RE: Appeal of San Francisco Planning Department's Final Mitigated Negative Declaration for 2417 Green Street, Case No. 2017-002545ENV. BOS File No. 200137

Re: Appeal of San Francisco Planning Department CEQA Mitigated Negative Declaration for 2417 Green Street, Case No. 2017-002545ENV

Subject: Comments on the 2417 Green Street Project

SCHEMATIC
PLAN

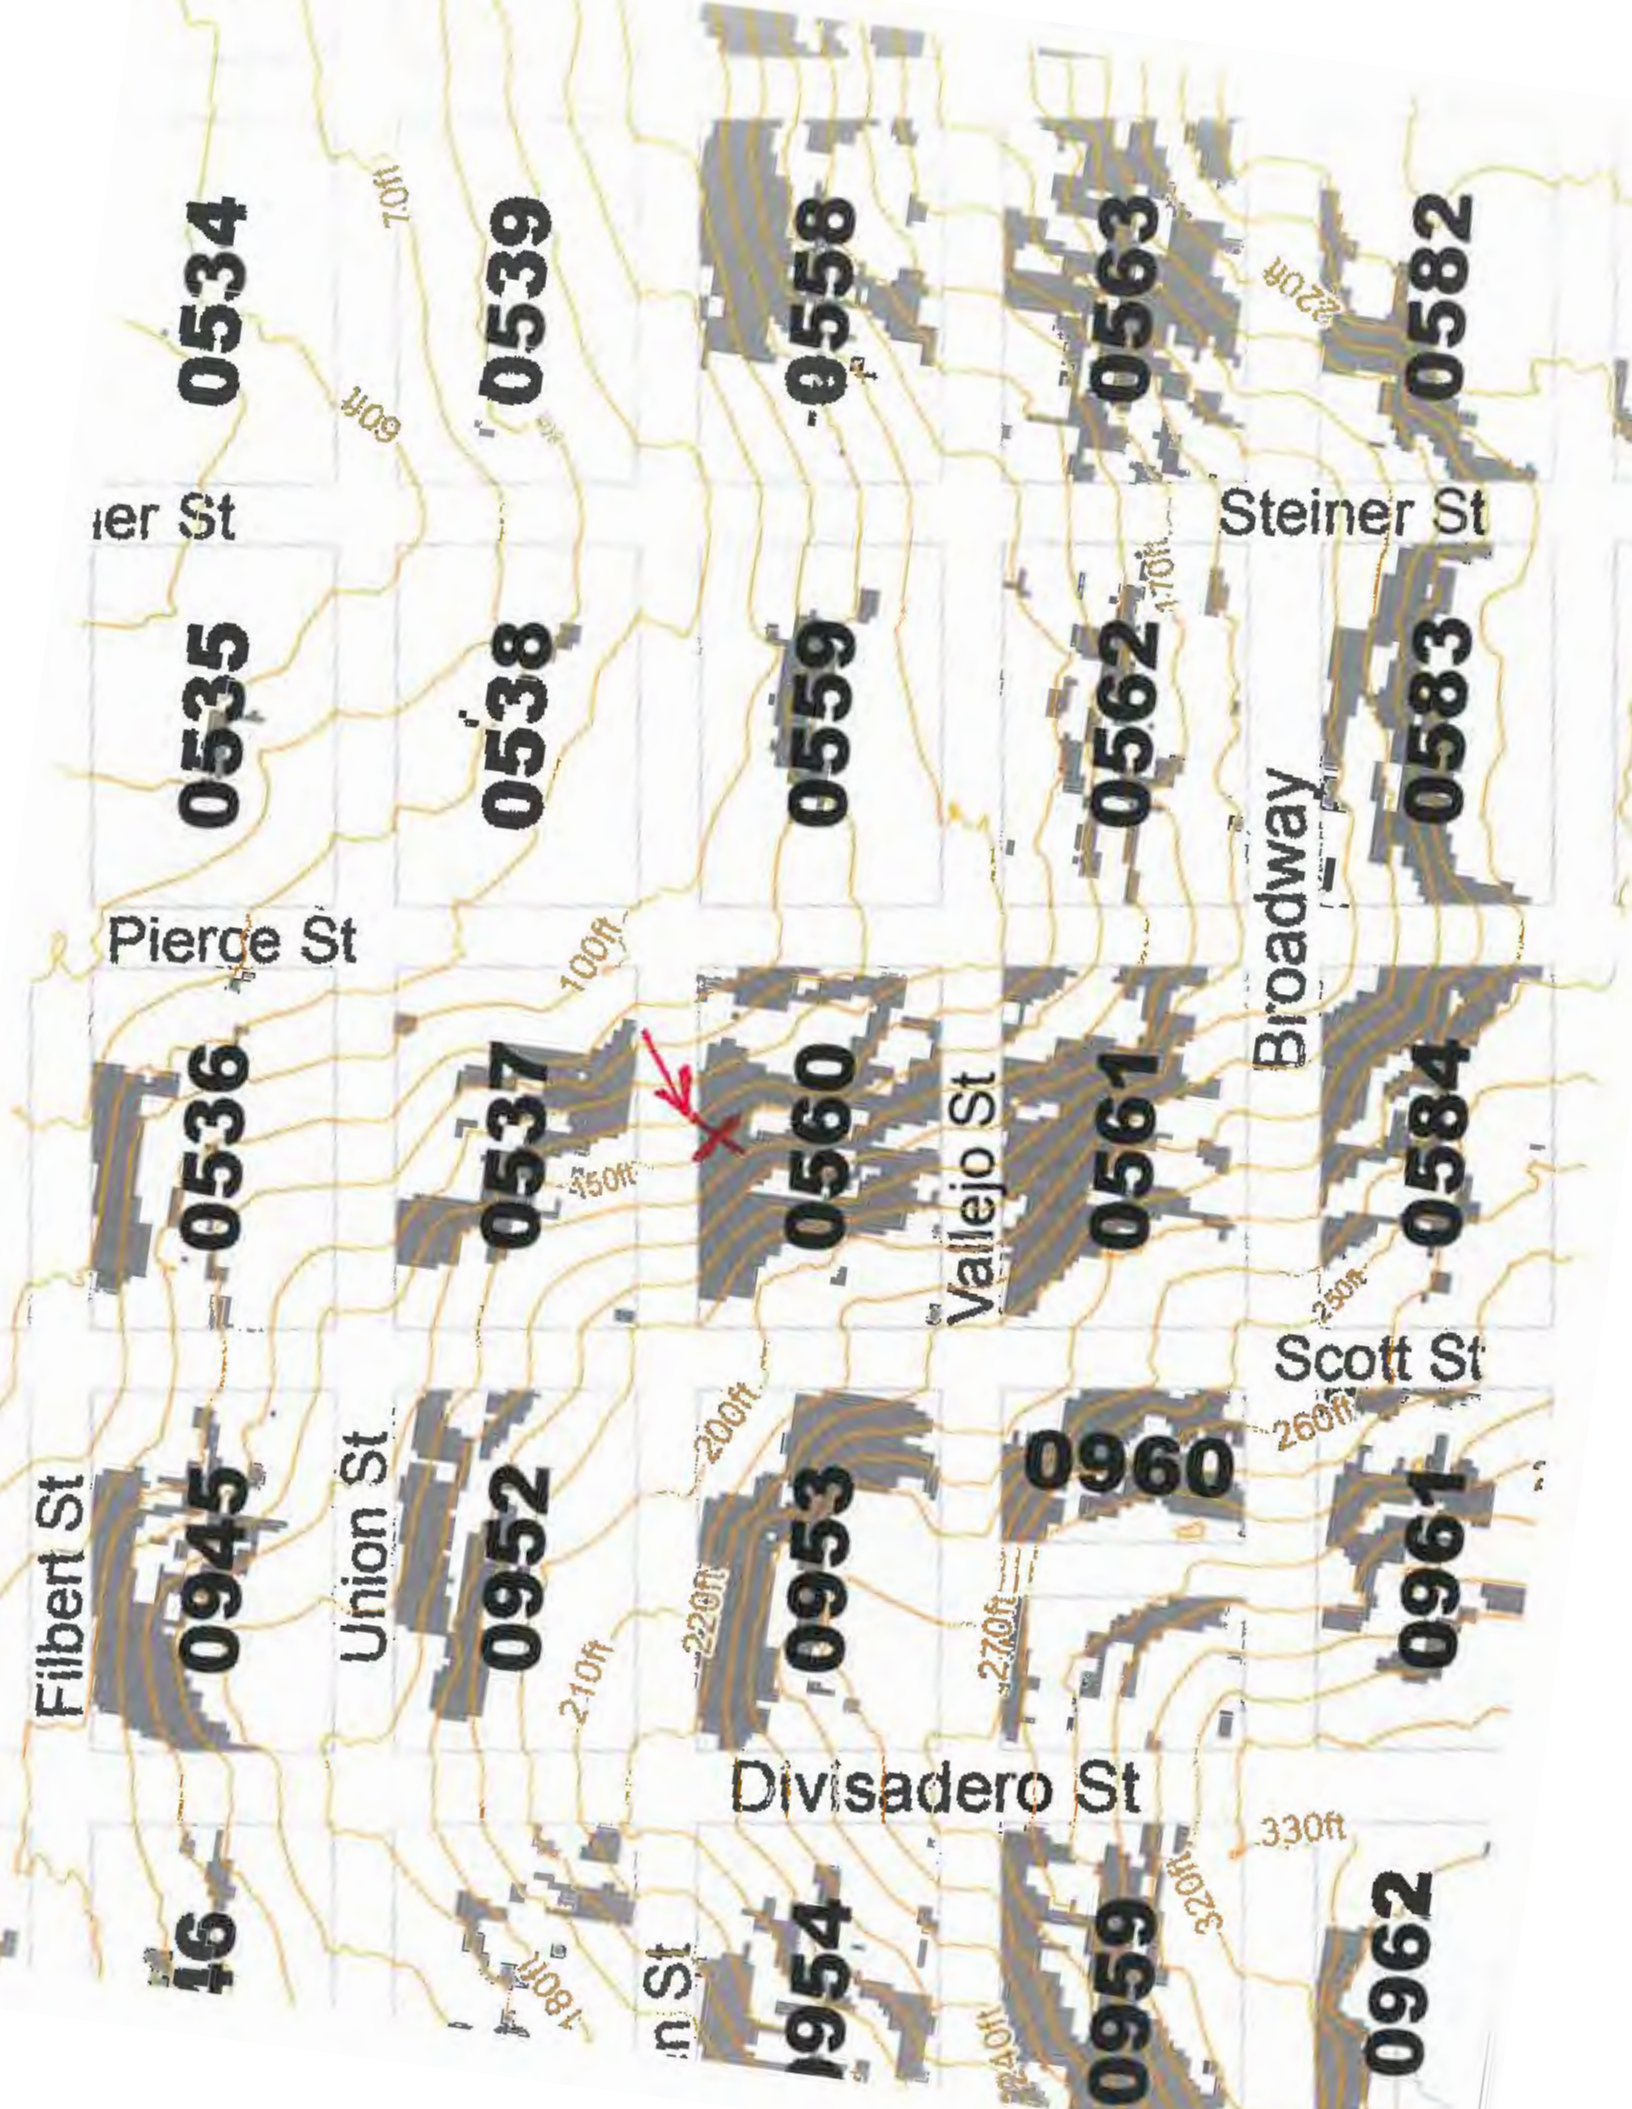
NO SURVEY
NO ENGINEERING

EXCAVATION HERE
WILL CAUSE DROP HERE
AND TENSION HERE
